**THEODORE K GUY
ASSOCIATES PC**

MOUNTAIN HOUSING GROUP

LOT 640C
TELLURIDE MOUNTAIN VILLAGE

SHEET TITLE:
FLOOR PLANS

① BLDGS 1, 2, 3 & 4 LOWER LEVEL
1/4"=1'-0"

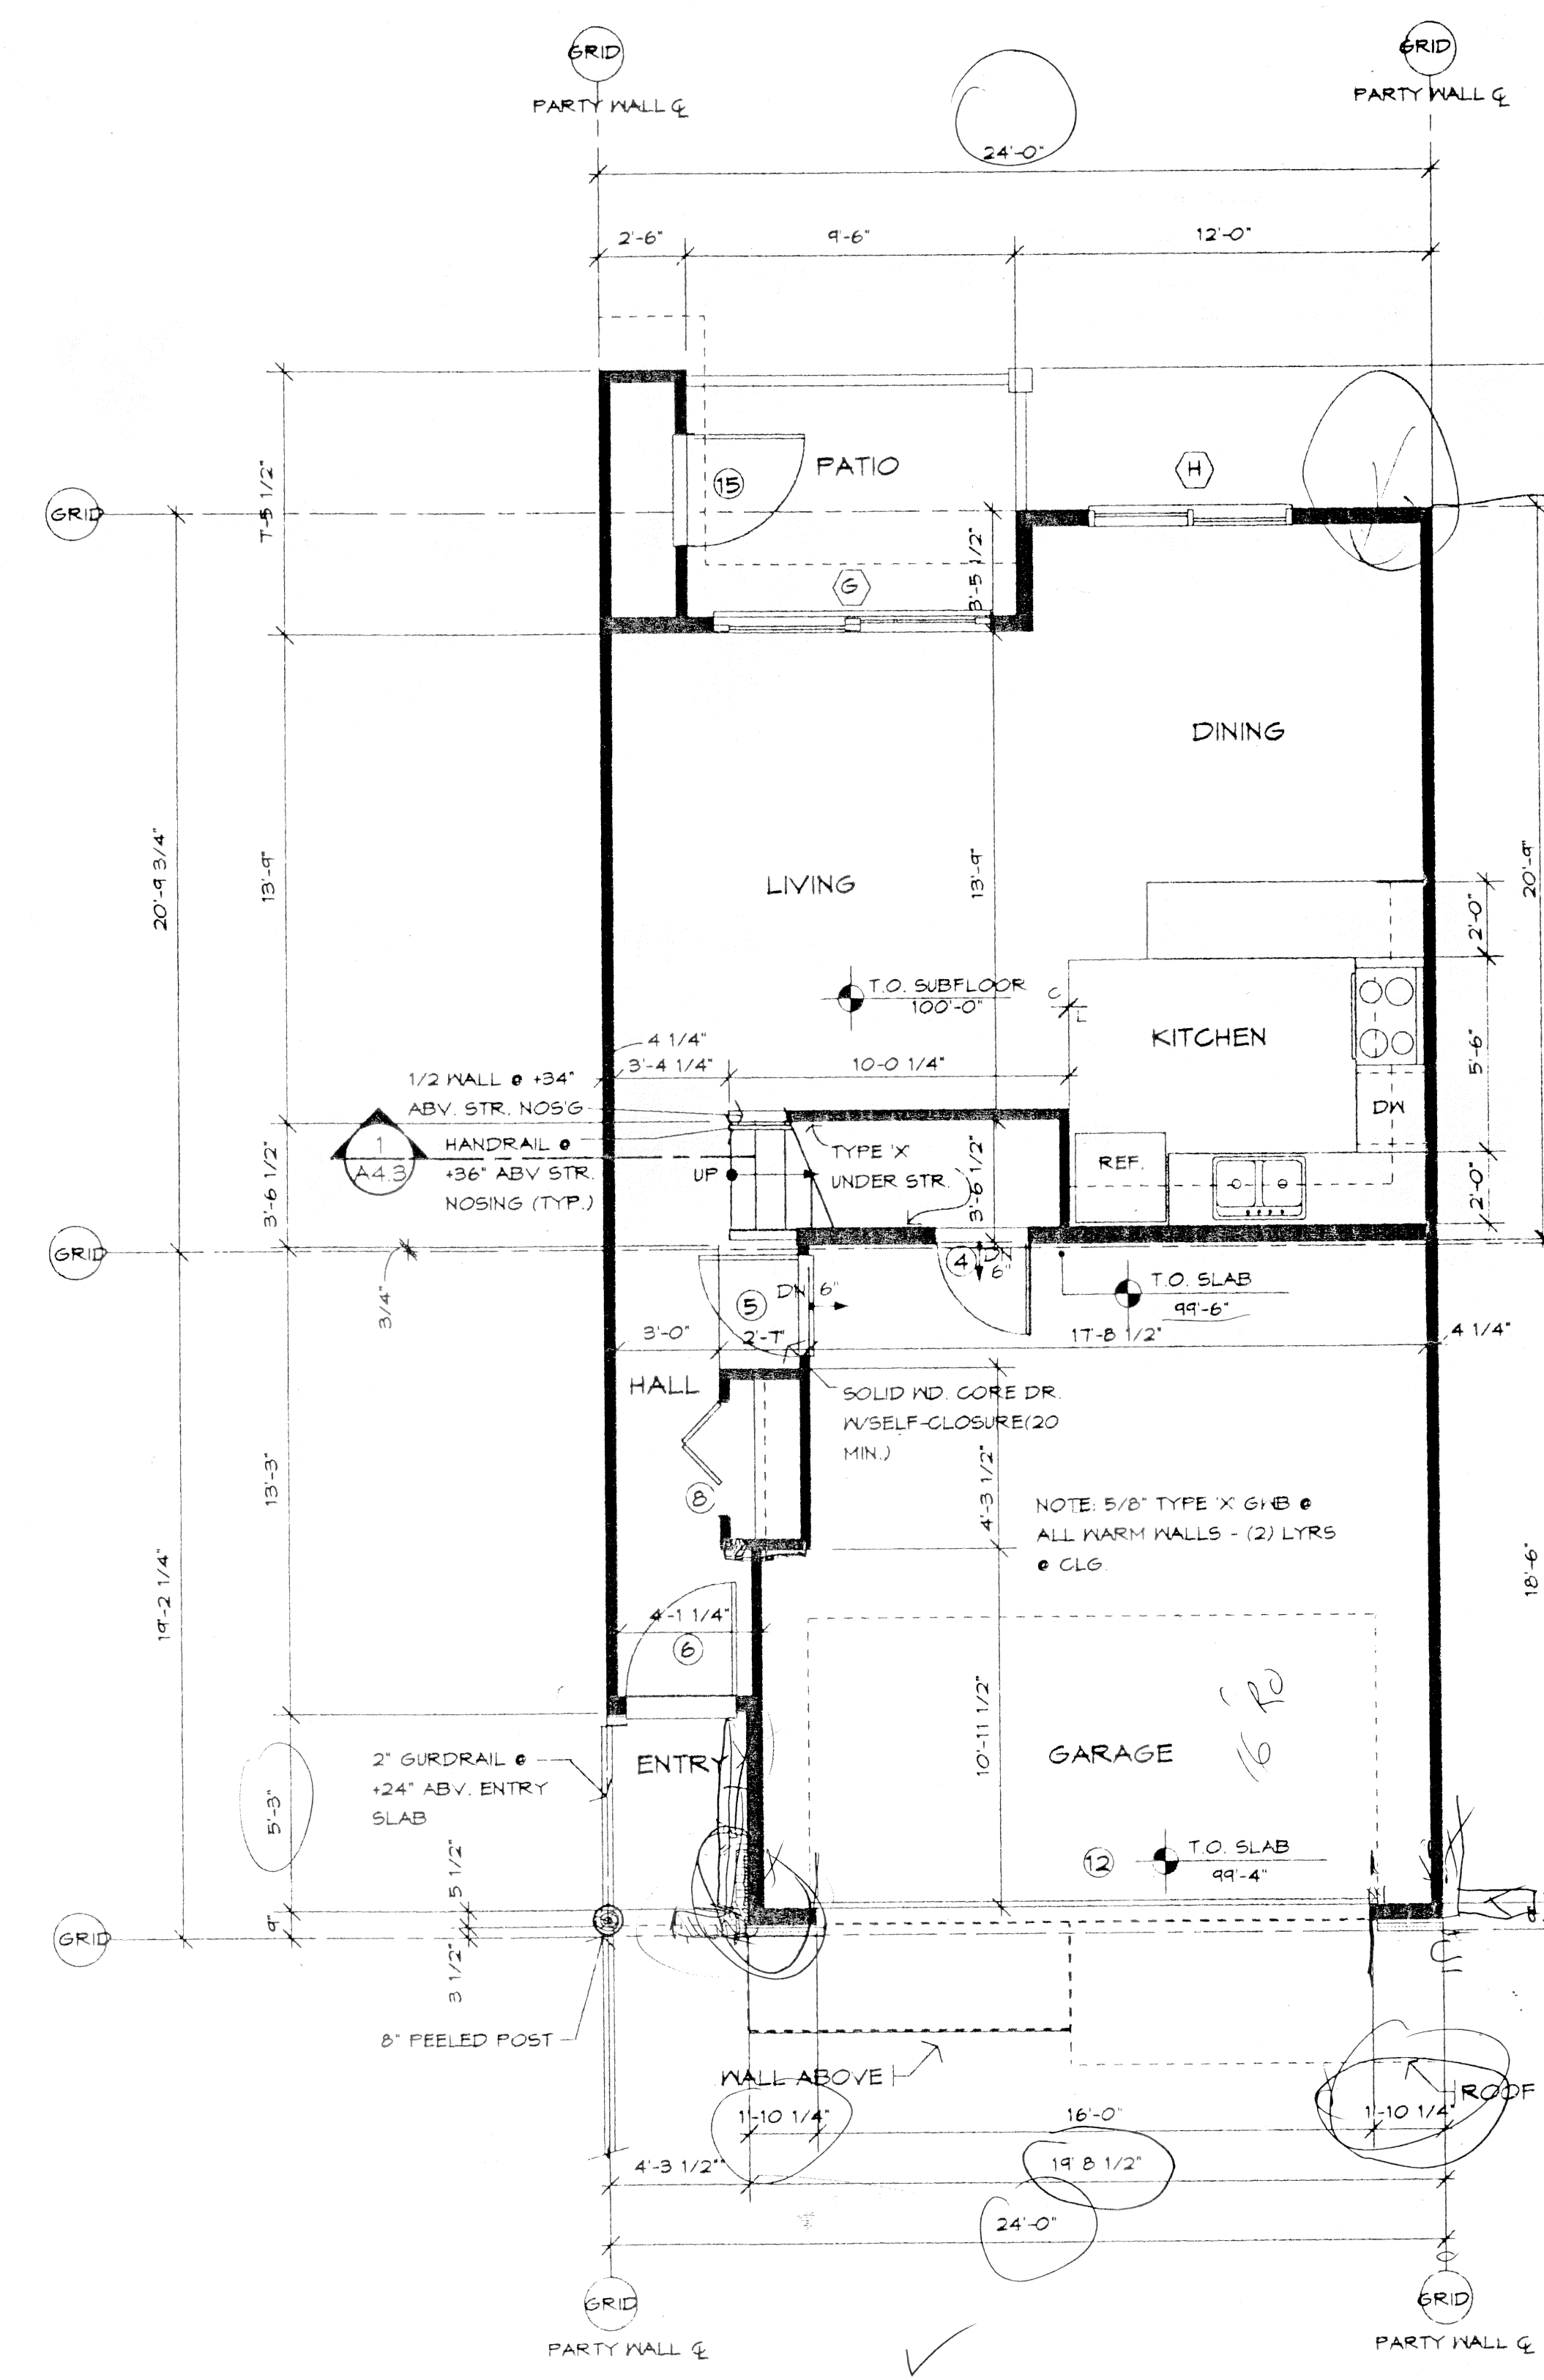
Handrails: Stairways with 4 or more risers shall have a handrail on at least one side at 34" - 38" above of tread Sec. 3306 (j) 3

Smoke detectors are required in each bedroom, bedroom corridor, on every level, wired to electrical system and have battery back-up Sec. 1210

Stairways are to have a max. rise of 8", min. run of 9", min. headroom of 6'8" and min. width of 36" Sec. 3306 (b) (c)

Units generating a spark or flame shall be raised 18" above the floor Sec. 508 UMC

② BLDGS 1, 2, 3 & 4 UPPER LEVEL
1/4"=1'-0"

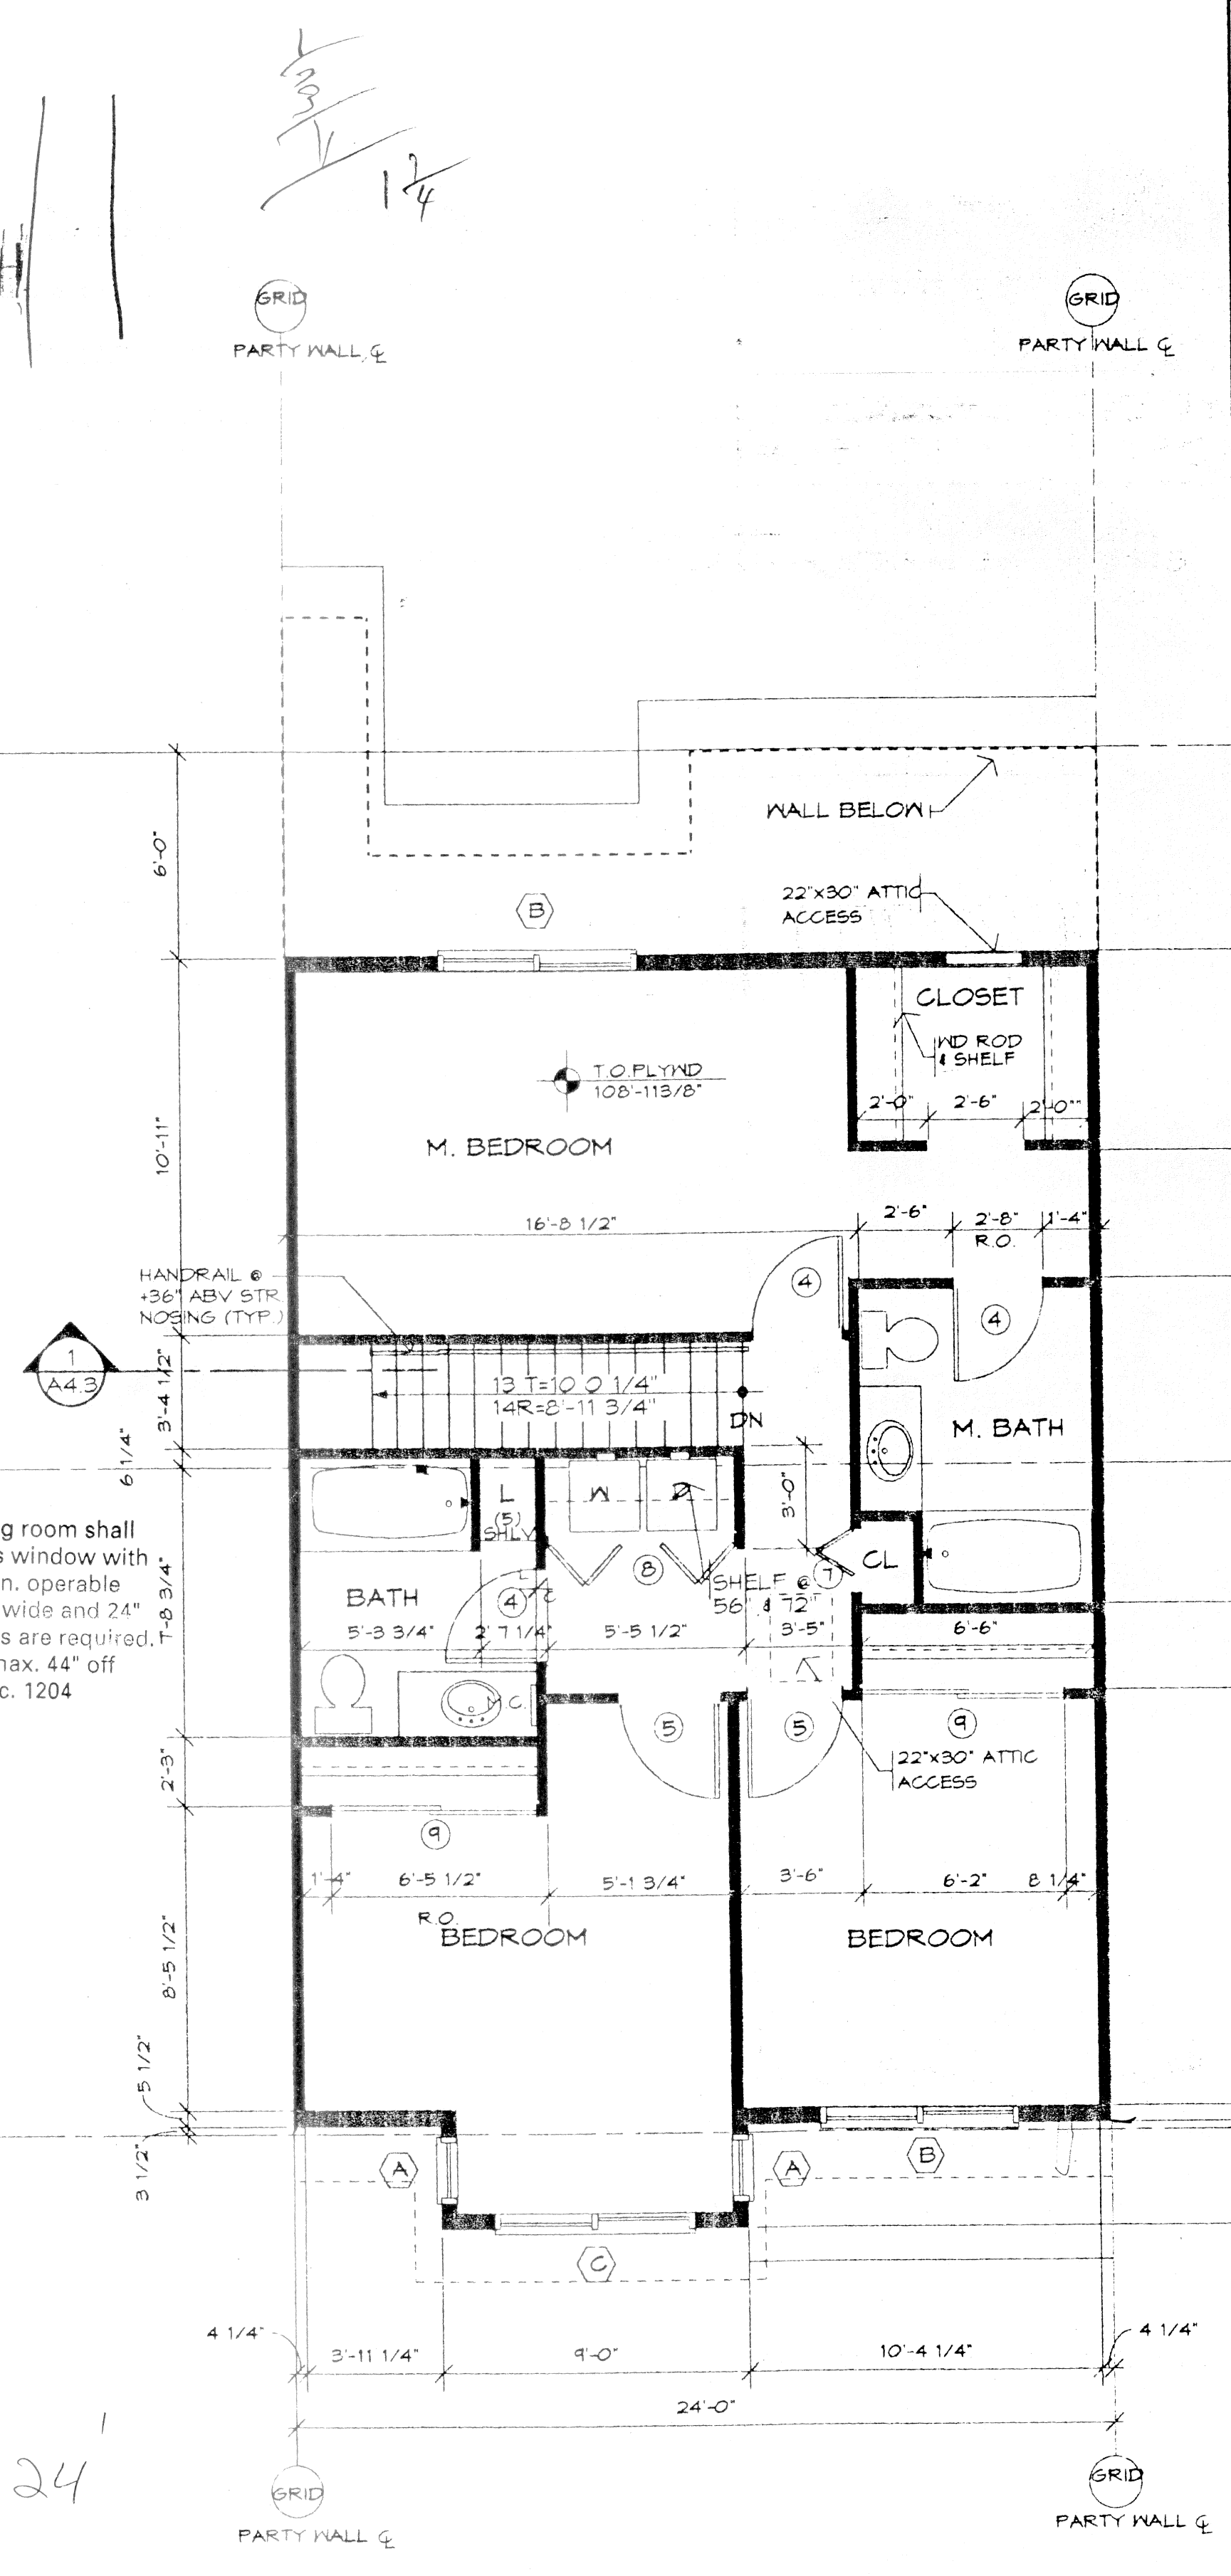
Doors from garage to house are to be min. 1 3/8" solid core with self-closing device, weatherstripped and threshold Sec. 503 (d) 3

Garage and house shall be separated by 1 hour fire resistive construction.
